### Inspection and/or replacement of expansion tank assy. for ROTAX® 912, 914, 912 i, 915 i and 916 i (Series) Aircraft Engines

ATA System: 75-20-00 Expansion Tank

**MANDATORY\***

## SERVICE BULLETIN

Fig. 1

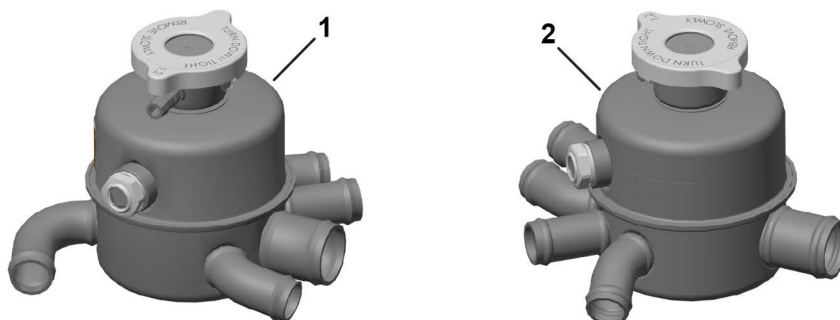
Due to a deviation in the manufacturing process, the individual components of the expansion tank assy. may not be sufficiently welded. Sealing of the assy. may be compromised and coolant leakage and subsequently an overheating of the engine may occur.

Fig.1/ pos.	part no.	Qty/ engine	Description
1	922668	(1)	EXPANSION TANK ASSY.
2	922666	(1)	EXPANSION TANK ASSY.
-	-	AR	COOLANT (as specified in the latest Service Instruction SI-912-016, SI-914-019, SI-912 i-001, SI-915 i-001,SI-916 i-001)

Fig. 5: GOOD Welding – total view / GOOD Welding – side view

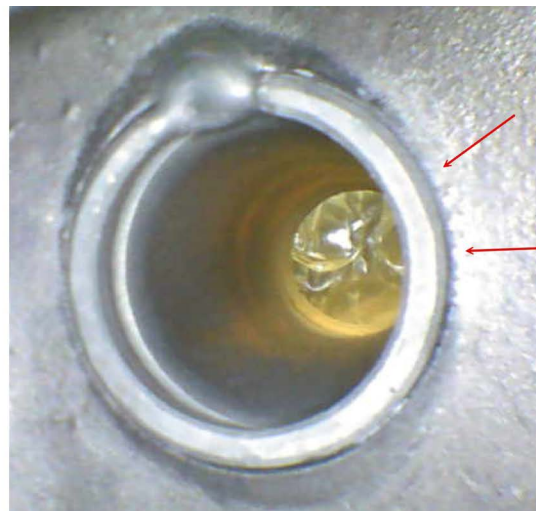
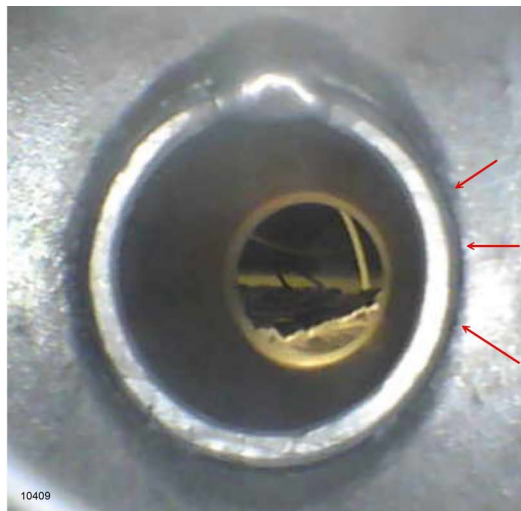
Step	Procedure
1	Remove the radiator cap from the expansion tank.
2	Perform an internal visual inspection using a bore-scope or similar device.
3	If the visual inspection shows consistent welding, the expansion tank assy. is serviceable (See Fig. 5), continue with section 3.6). <b>NOTE:</b> Welding must be present and contiguous around every connection.
4	If the visual inspection shows any connection with inconsistent or missing welds, the expansion tank assy. is unserviceable and must be replaced (See Fig. 6).
5	Apply small amount of coolant to rubber surfaces inside radiator cap (provides lubrication to prevent binding). Tighten the radiator cap by hand.
